Re: Inland Empire Energy Center (Docket No. 01-AFC-17):
Visual Analysis and Revised Landscaping Plan – Response to PSA Workshop

Visual Analysis and Revised Landscaping Plan

Response to PSA Workshop

Inland Empire Energy Center

Figure 1
Schematic for Screening Calculations

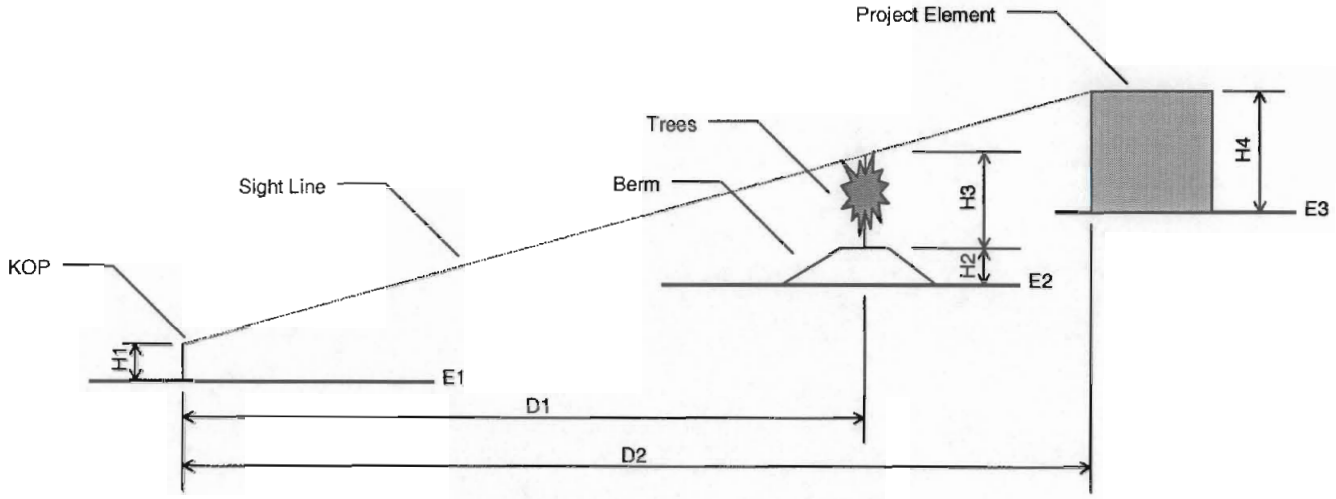
A quantitative analysis was then performed to determine how best to maximize the screening of the larger project structures from the various KOPs. First, the larger project structures visible from each KOP were identified and the desired level of screening for each structure was established based on the equipment dimensions found in Table 5.10-2 of the AFC. Figure 1, Schematic for Screening Calculations, depicts the method for estimating the height of screening required to screen each of the larger project structures in the view from a particular KOP. The Legend in Figure 1 explains each of the parameters used in the detailed calculations.

calculations. Using the parameters defined in Figure 1 and the initial planting height and annual growth rate of the proposed landscaping, calculations were made to determine the number of years necessary to achieve the desired level of screening.

Figure B-1
Landscape Berm Schematic

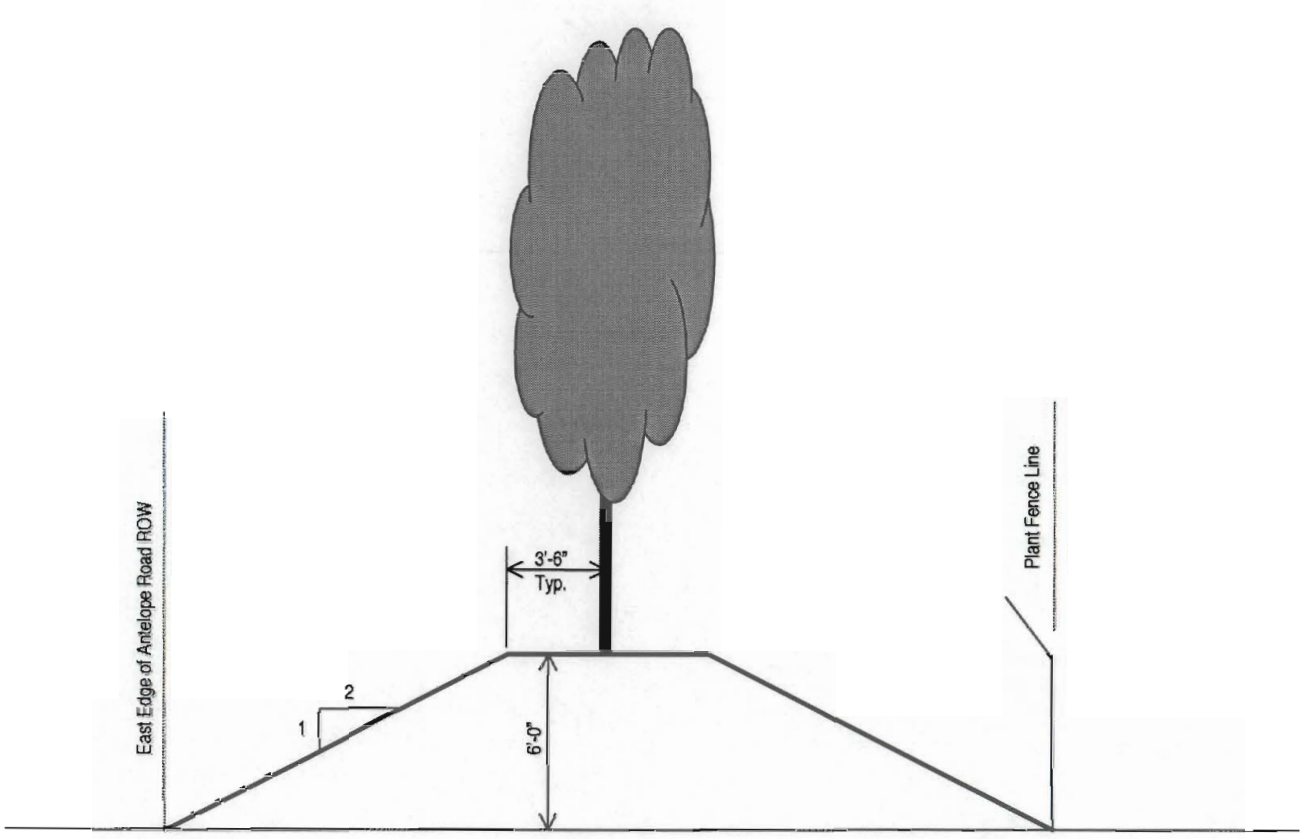
The Applicant is also proposing to add an approximately 6-foot high berm along the west side of the IEEC site, decreasing the time to screen the larger project structures from the key KOPs. The area to be bermed is shown in Figure 2, and Appendix B contains a schematic of the proposed berm. In addition, the Applicant is proposing to plant screening trees in the most-critical areas at mobilization rather than commercial operation in order to further reduce the time required to achieve the desired level of screening of the larger project elements.
